## REVISED RESPONSE TO REQUEST FOR ADDITIONAL INFORMATION

### APR1400 Design Certification

Docket No. 52-046

**RAI No.:** 129-8085  
**SRP Section:** 03.08.01 –Concrete Containment  
**Application Section:** 03.08.01  
**Date of RAI Issue:** 08/05/2015

Figure 5-4 Containment Pressure for Loss of RHR (Mode 5)

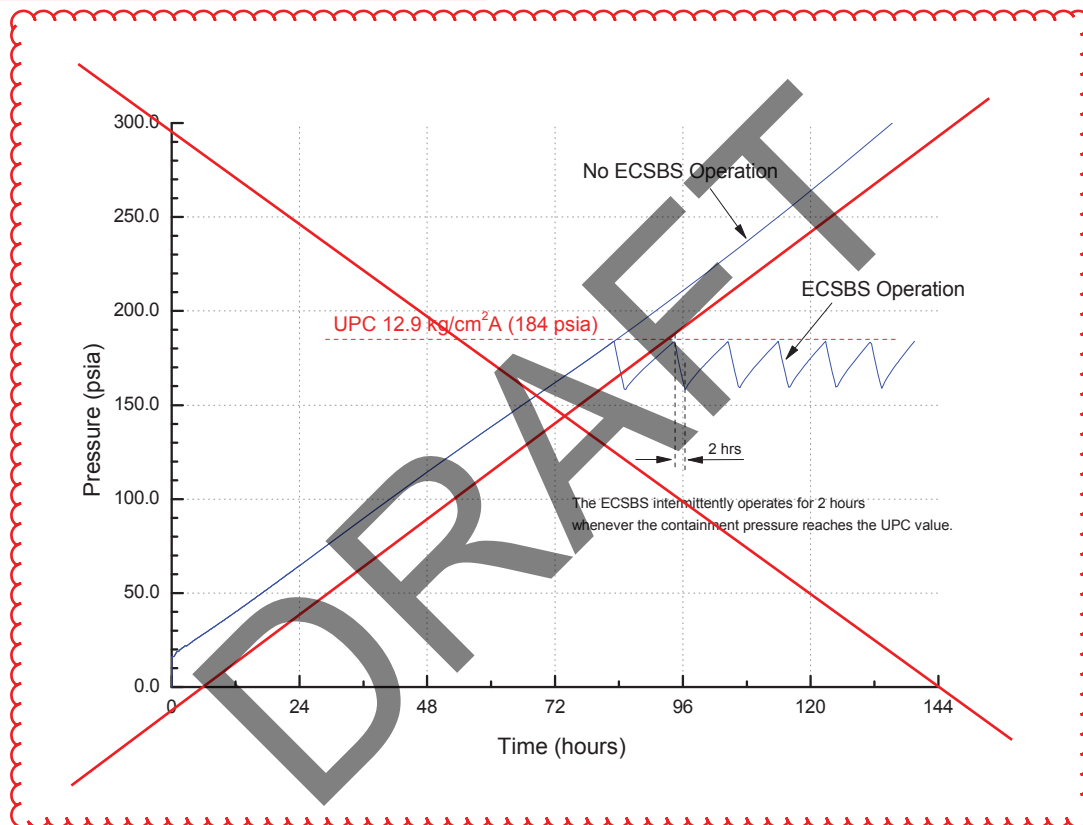
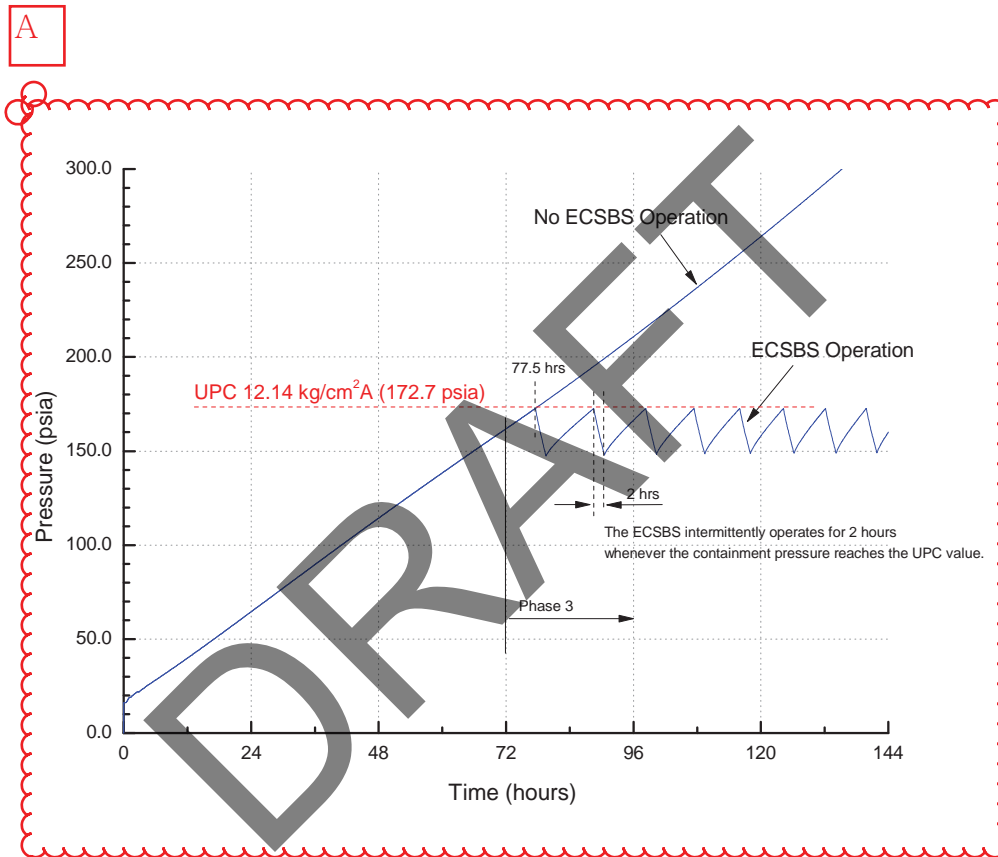
In reviewing DCD Section 3.8.1.4.11 of the application, the staff noted that additional information is needed to better understand the applicant's approach for determining the UPC of the containment. Standard Review Plan (SRP) 3.8.1, Section II.4.K discusses the regulatory criteria for determining the internal pressure capacity of the containment. SRP 3.8.1 states that the design and analysis procedure for the UPC of the containment is acceptable if performed in accordance with Regulatory Guide (RG) 1.216, "Containment Structural Integrity Evaluation for Internal Pressure Loadings Above Design-Basis Pressure."

In accordance with SRP 3.8.1, and GDC 16, the applicant is requested to provide a detailed description of the approach used to calculate the UPC of the containment identified in Section 3.8.1.4.11 of the DCD and explain how this approach compares to that described in Regulatory Position 1 of the RG 1.216.

Due to the mass and energy released from the RCS, containment pressure increases consistently from the beginning of the event, but it can be maintained below UPC by operating the ECSBS intermittently after reaching UPC ~~at around 83 hours~~. The ECSBS is assumed to start spraying water into the containment atmosphere via a FLEX pump when the containment pressure reaches the UPC value of ~~12.9 kg/cm<sup>2</sup> A (184 psia)~~. After the initial operation, the ECSBS is assumed to be intermittently operated for 2 hours whenever the containment pressure reaches the UPC value. The FLEX pump provides the flow rate of 2,839 L/min (750 gpm) and the differential pressure of at least 2.8 kg/cm<sup>2</sup> (40 psi) at the ECSBS nozzle. The external water source for ECSBS operation is the RWT.

GOTHIC analyses are performed for evaluation of the containment pressure and temperature responses following loss of RHR in mode 5. Figure 5-4 shows that the containment pressure reaches the UPC value in about ~~3.5 days~~ without ECSBS operation, but with the intermittent operation of ECSBS, containment pressure can be maintained within the UPC limit. Figure 5-5 shows that the containment temperature is maintained well below 185 °C (365 °F), which is less than the upper limit temperature of 196 °C (385 °F) for ensuring the operability of RCS sensors.

Replaced with next page, A
